AS-BUILT DRAINAGE/GRADING PLAN FOR MONTESSORI ESQUELA DEL SOL @ 1114 7TH STREET N.W.

AS-BUILT GRADING AND DRAINAGE PLAN

Project Name
MONTESSORI ESQUELA DEL SOL
1114 7TH STREET, N.W.

GD-1

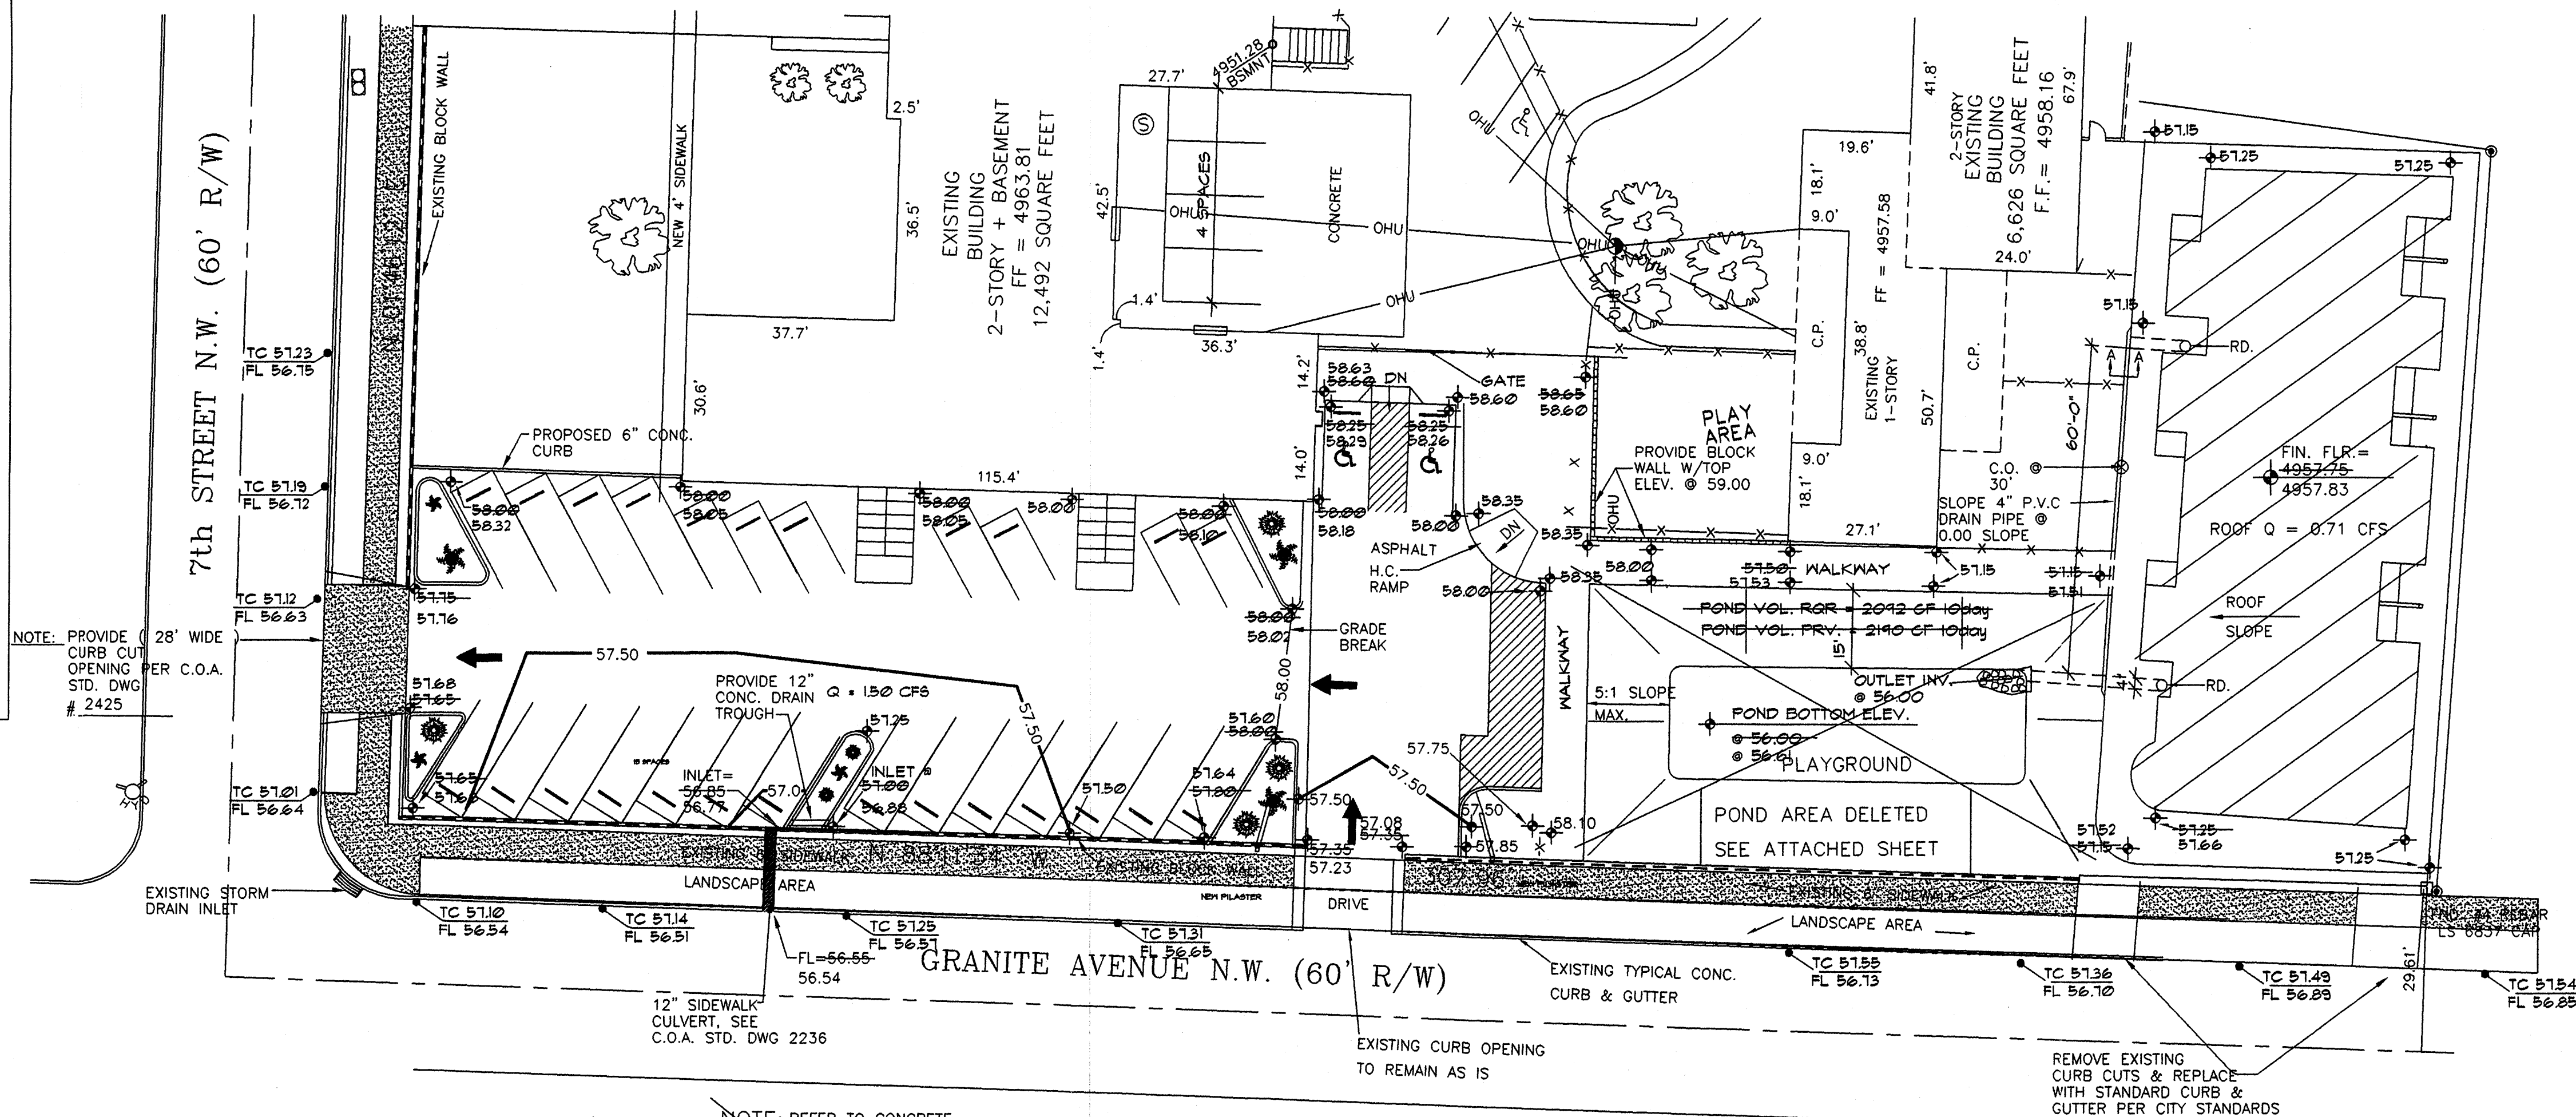
1. THE PROPOSED PONDING AREA WITHIN THE PLAYGROUND AREA WAS CHANGED TO AN UNDERGROUND FRENCH DRAIN TYPE SYSTEM SHOWN ON SHEET 2 OF 2. CONVERSATION WITH MR. BRAD BINGHAM FROM CITY HYDROLOGY DEPARTMENT ALLOWED THE CHANGE

THIS DEVIATION DOES NOT IMPACT THE DRAINAGE CONCEPT IN ANY WAY. THE SITE DRAINAGE WILL FUNCTION IN ACCORDANCE WITH THE PATTERN ESTABLISHED BY THE APPROVED PLAN. THEREFORE A PERMANENT CERTIFICATE OF OCCUPANCY IS HIGHLY RECOMMENDED. THE AS-BUILT INFORMATION SHOWN HEREON WAS OBTAINED BY ME OR UNDER MY DIRECT SUPERVISION AND IS TRUE AND CORRECT TO THE BEST OF MY KNOWLEDGE AND BELIEF.

Sheet Title
AS-BUILT UNDERGROUND RUN-OFF STORAGE
Drawn By: BJM
Checked By:

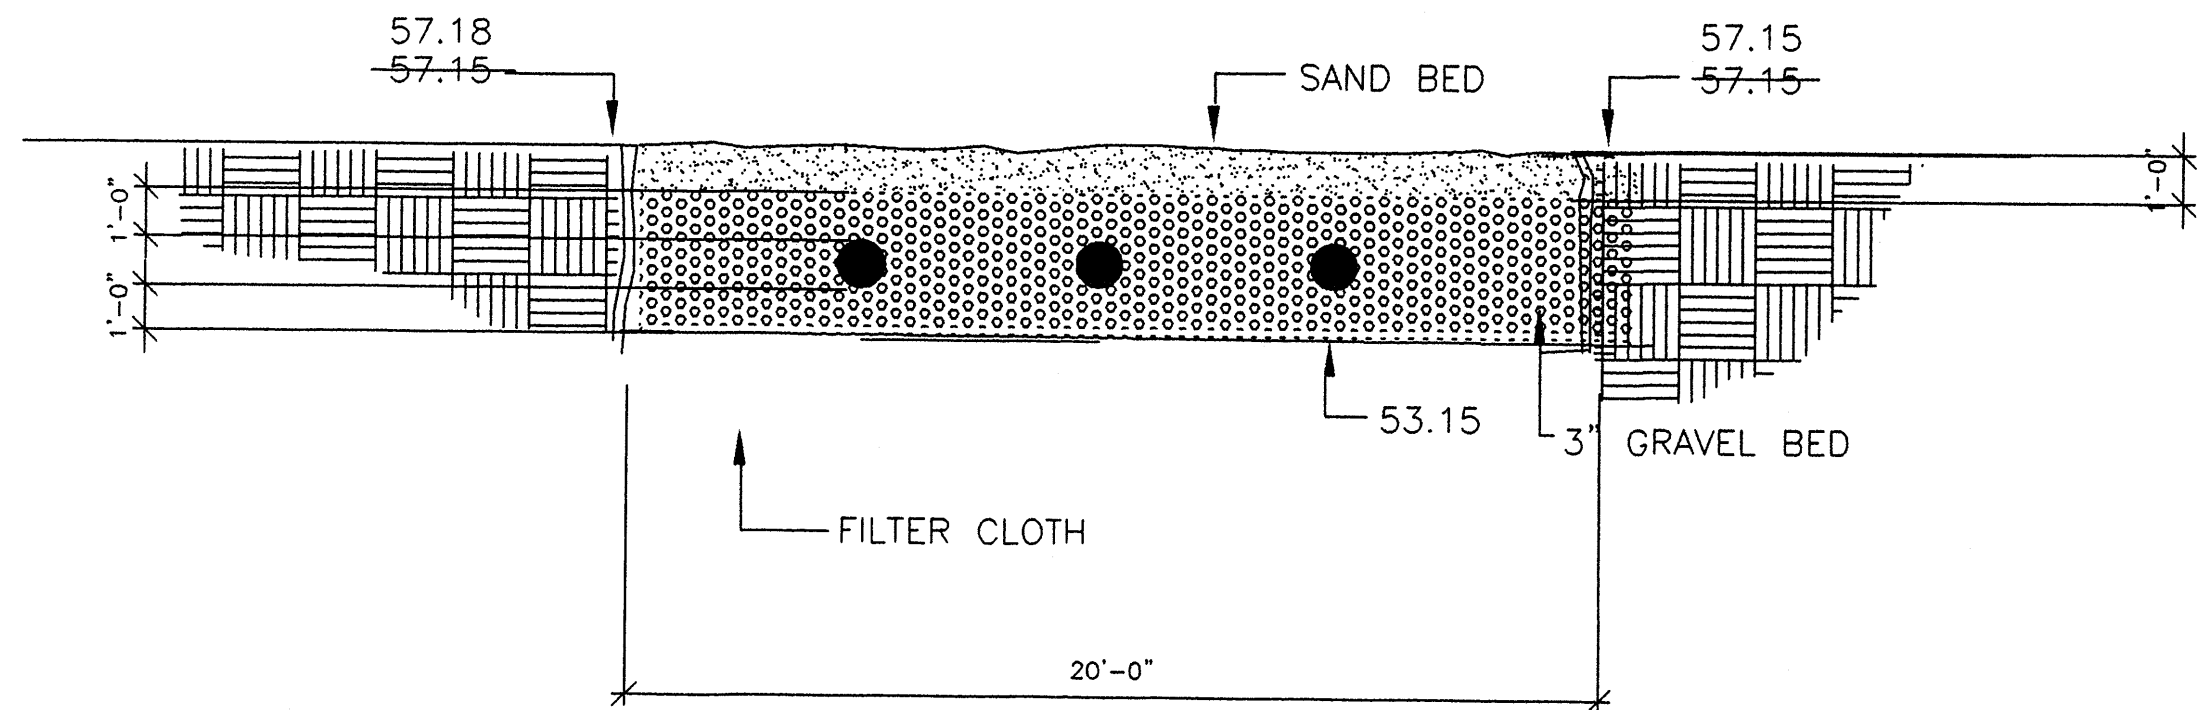
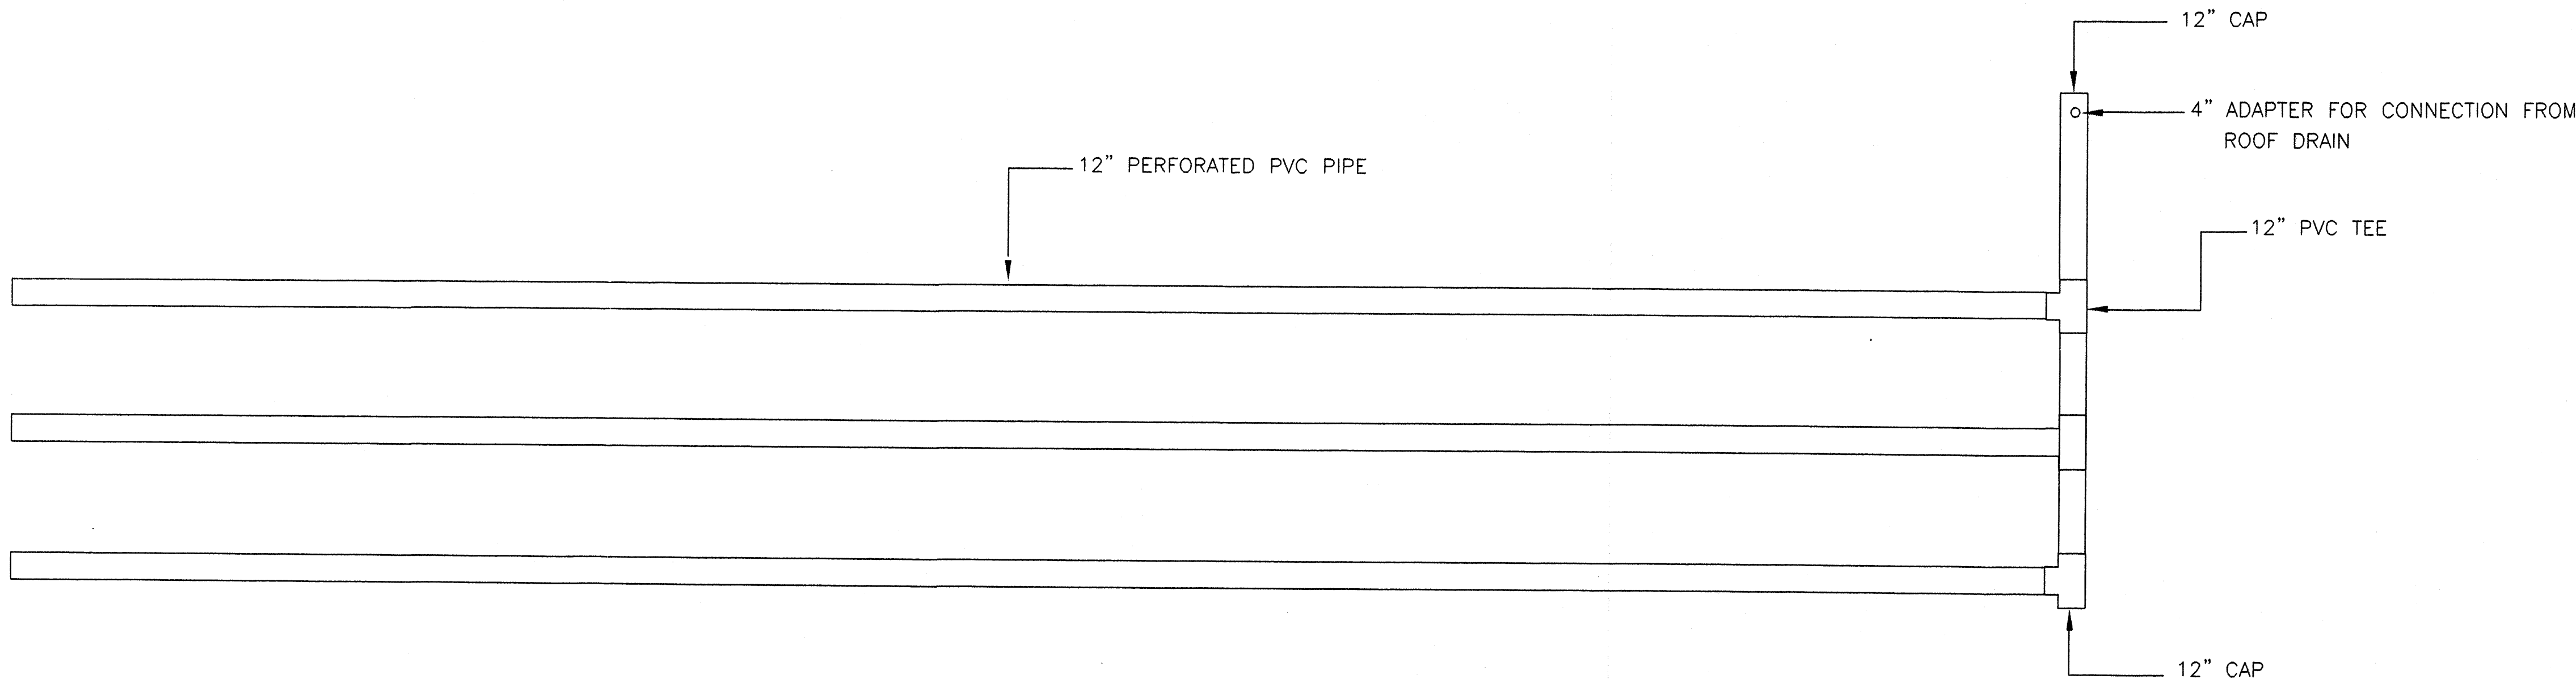
1. THE PROPOSED PONDING AREA WITHIN THE PLAYGROUND AREA WAS CHANGED TO AN UNDERGROUND FRENCH DRAIN TYPE SYSTEM SHOWN ON SHEET 2 OF 2. CONVERSATION WITH MR. BRAD BINGHAM FROM CITY HYDROLOGY DEPARTMENT ALLOWED THE CHANGE

V100-10DAY ROOF = 1620 CF
12" PERFORATED PVC PIPE VOLUME = 0.785 X 75' = 58.88 CF X3 = 176.63 CF
FRENCH DRAIN 20'X3'X75'X.33 = 1485 CF
REQUIRED 1620 CF PROVIDED 1661.6 CF
SEE CALCS ON SPREAD SHEET FOR VOLUMES

THIS DEVIATION DOES NOT IMPACT THE DRAINAGE CONCEPT IN ANY WAY. THE SITE DRAINAGE WILL FUNCTION IN ACCORDANCE WITH THE PATTERN ESTABLISHED BY THE APPROVED PLAN. THEREFORE A PERMANENT CERTIFICATE OF OCCUPANCY IS HIGHLY RECOMMENDED. THE AS-BUILT INFORMATION SHOWN HEREON WAS OBTAINED BY ME OR UNDER MY DIRECT SUPERVISION AND IS TRUE AND CORRECT TO THE BEST OF MY KNOWLEDGE AND BELIEF.
